SUBJECT: SHEARON HARRIS NUCLEAR POWER PLANT, UNIT 1 - STAFF ASSESSMENT OF INFORMATION PROVIDED PURSUANT TO TITLE 10 OF THE *CODE OF FEDERAL REGULATIONS* PART 50, SECTION 50.54(f), SEISMIC HAZARD REEVALUATIONS FOR RECOMMENDATION 2.1 OF THE NEAR-TERM TASK FORCE REVIEW OF INSIGHTS FROM THE FUKUSHIMA DAI-ICHI ACCIDENT (TAC NO. MF3952)

STAFF ASSESSMENT BY THE OFFICE OF NUCLEAR REACTOR REGULATION

RELATED TO SEISMIC HAZARD AND SCREENING REPORT

SHEARON HARRIS NUCLEAR POWER PLANT, UNIT 1

Figure 3.3-1 Plot of Licensee's Base Case Shear-Wave Velocity Profiles for the HNP site

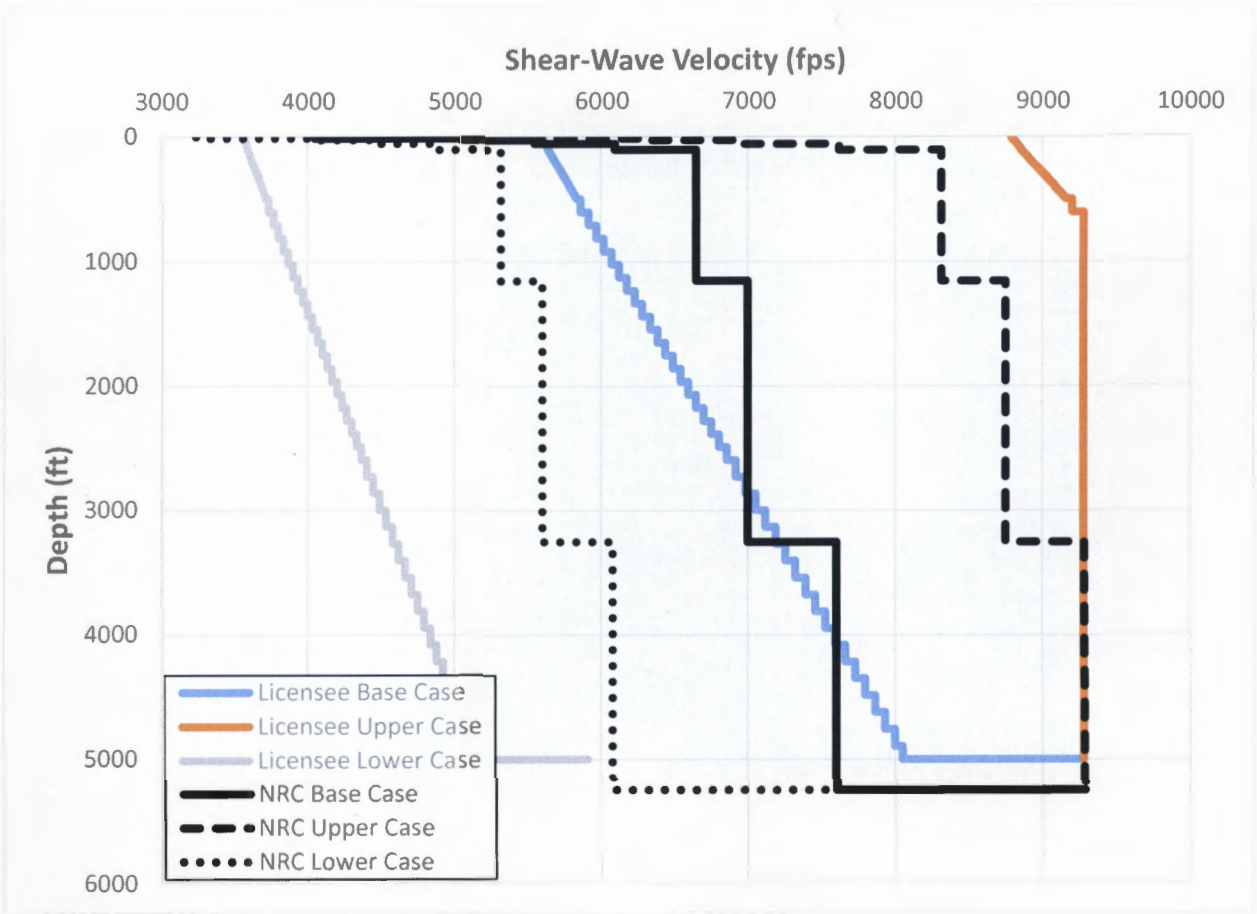
because the operating unit is close to the COL site and the site geology is relatively uniform. However, because the COL FSAR indicates that the shear wave velocities in the upper sections vary laterally, the NRC staff used three base case profiles rather than just one profile. The NRC staff modeled the upper 14 ft. (4.3 m) with a best-estimate velocity of 4050 ft./sec (1234 m/s), and used information in the COL FSAR (Progress Energy, 2012) to extend the profile to a total depth of 5255 ft. (1601 m). To estimate the upper and lower base case profiles, the NRC staff used a natural log standard deviation of 0.17. This value, while lower than that used by the licensee, is consistent with the amount and quality of data available near the HNP site. The NRC staff randomized the depth to reference rock by ± 10 percent to allow for additional uncertainty in the depth to base rock. Figure 3.3-1 of this assessment shows a comparison of the three velocity profiles developed by the licensee with those developed by the NRC staff. The profiles developed by the licensee cover a wider range of shear wave velocities from those of the NRC staff but both follow a similar trend as they extend to base rock.

Figure 3.3- 1 Plot Comparing the Staff's and the License's Median Amplification Functions and Uncertainties for the HNP site

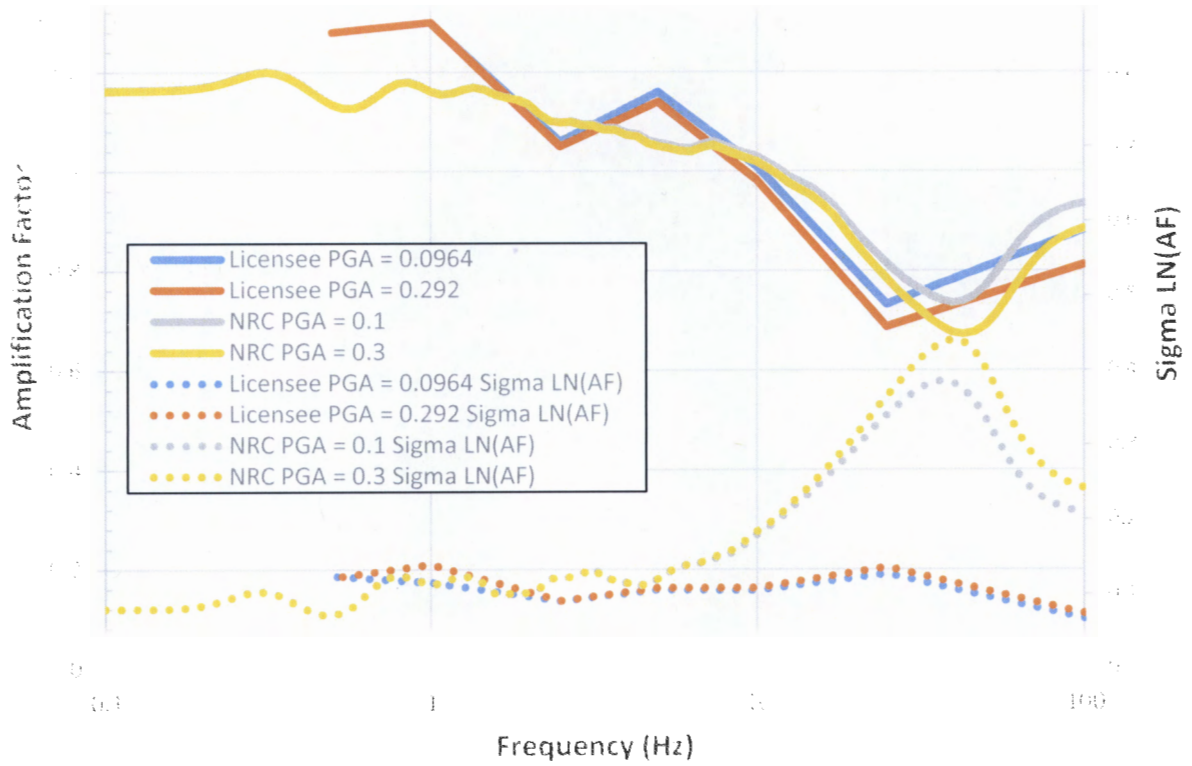
Figure 3.3-2 of this assessment shows a comparison of the staff's and the licensee's median site amplification functions and uncertainties (± 1 standard deviation) for two of the eleven input loading levels. Peaks in the amplification functions occur at approximately 1 and 5 Hz in the licensee's analysis, while the staff's analysis resulted in relatively constant amplification functions below 2 Hz, and a modest decrease between 2 and approximately 10 Hz. There are large differences in uncertainties at high frequencies due to the NRC staff using greater uncertainties in both kappa and damping parameters. Differences in site amplification curves developed by the NRC staff and the licensee are due to differences in site velocities, kappa values, and damping parameters.

Figure 3.3-2 Plot Comparing the Staff's and the Licensee's Mean Control Point Hazard Curves at a Variety of Frequencies for the HNP site

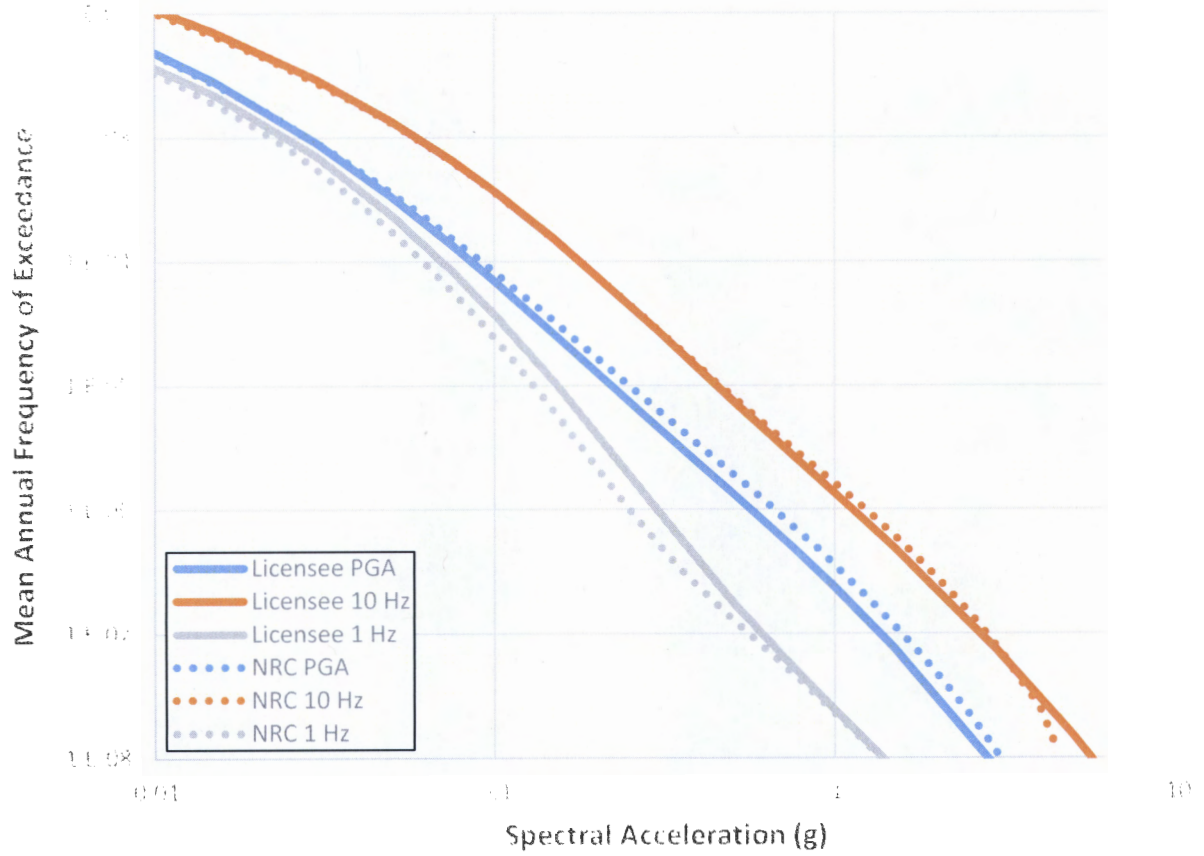
The licensee's approach to modeling the subsurface soil and rock properties and their uncertainties results in amplification factors that are broadly similar to those produced by the NRC staff, with the exceptions noted above. As shown in Figure 3.3-3 of this assessment, these differences in site response have a minor impact on control point seismic hazard curves and the resulting GMRS, discussed below. Appendix B of the SPID provides guidance for performing site response analyses, including capturing the uncertainty for sites with less subsurface data; however, the guidance is neither entirely prescriptive nor comprehensive. As

Figure 3.4-1 Comparison of the Staff's GMRs with Licensee's GMRs and the SSE for the HNP site

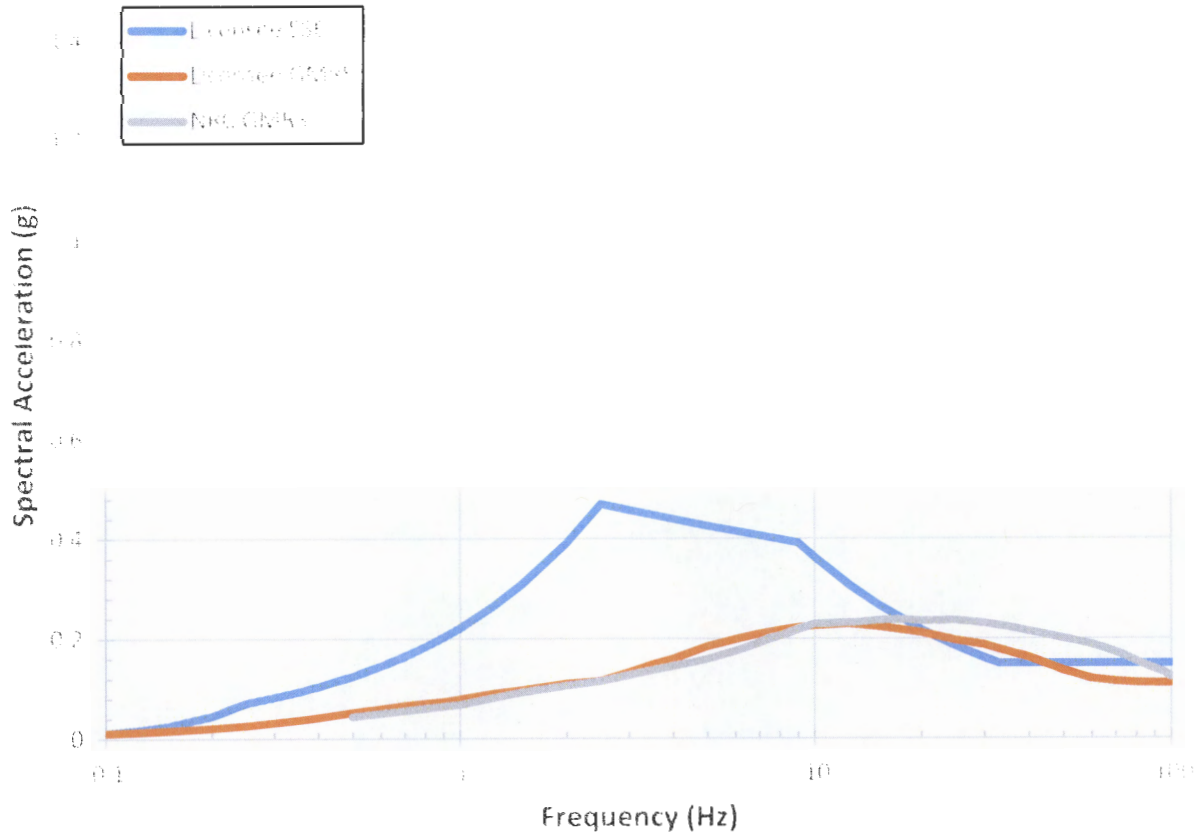
The NRC staff independently calculated the 10^{-4} and 10^{-5} UHRS using the results of its confirmatory PSHA and site response analyses, as described in Sections 3.2 and 3.3 of this staff assessment, respectively. Figure 3.4-1 of this assessment shows a comparison of the GMRS determined by the licensee to that determined by the NRC staff.

As shown in Figure 3.4-1, the licensee's GMRS is similar to the staff's confirmatory GMRS. However, the NRC's GMRS is slightly higher than the licensee's GMRS at frequencies above 15 Hz. As described above in Section 3.3, the NRC staff notes that these differences are the result of differences in the site response analyses performed by the licensee and the NRC staff.

The NRC staff confirms that the licensee used the present-day guidance and methodology outlined in RG 1.208 and the SPID to calculate the horizontal GMRS, as requested in the 50.54(f) letter. The NRC staff performed both a PSHA and site response confirmatory analysis and achieved results consistent with the licensee's horizontal GMRS. As such, the NRC staff concludes that the GMRS determined by the licensee adequately characterized the reevaluated hazard for the HNP site. Therefore, this GMRS is suitable for use in subsequent evaluations and confirmations, as needed, for the response to the 50.54(f) letter.
